Appendix D

Technical Advisory Committee and Stakeholder Advisory Committee Meeting Minutes

Subject: 052314-MCEA Schedule C Warden Avenue and Kennedy Road between Major Mackenzie Drive to Elgin Mills Road, in the City of Markham Technical Advisory Committee

Preferred Design Concept

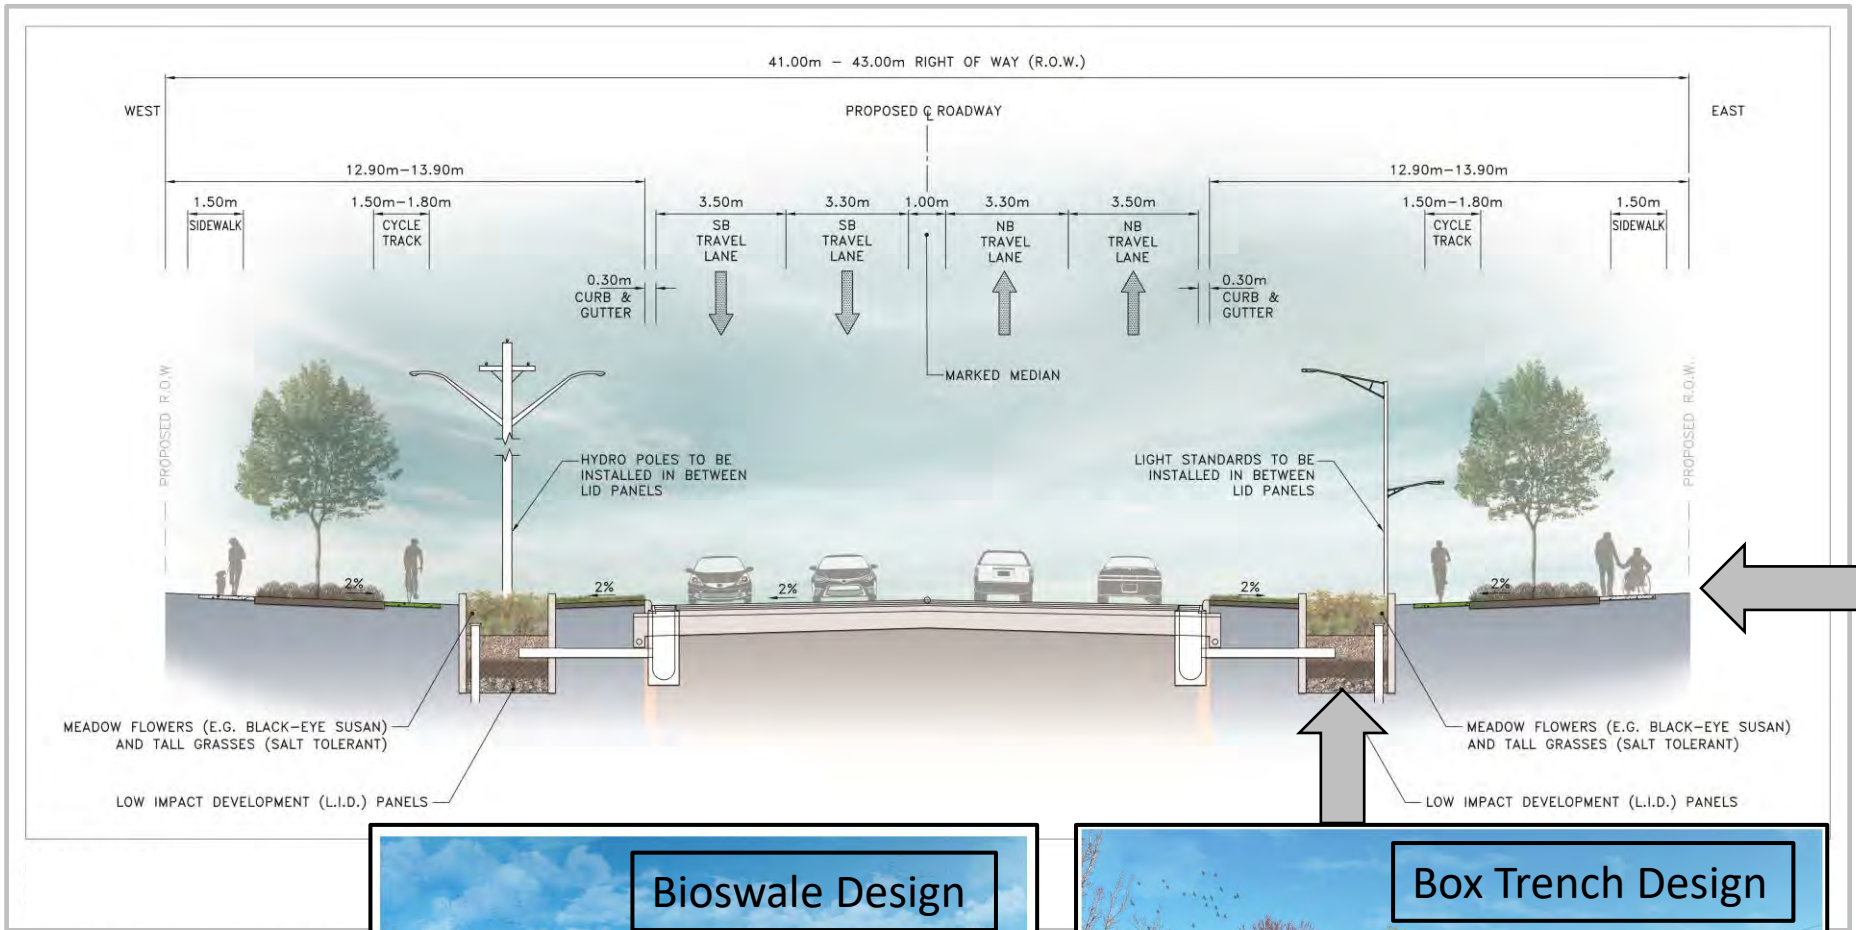
Feedback from City Meeting (Sep 6, 2022)	How Feedback addressed
Preference for separation of sidewalk and cycle track and preferred width of 1.8m cycle track.	A minimum 1.5m cycle track is provided in the preferred design concept plans.
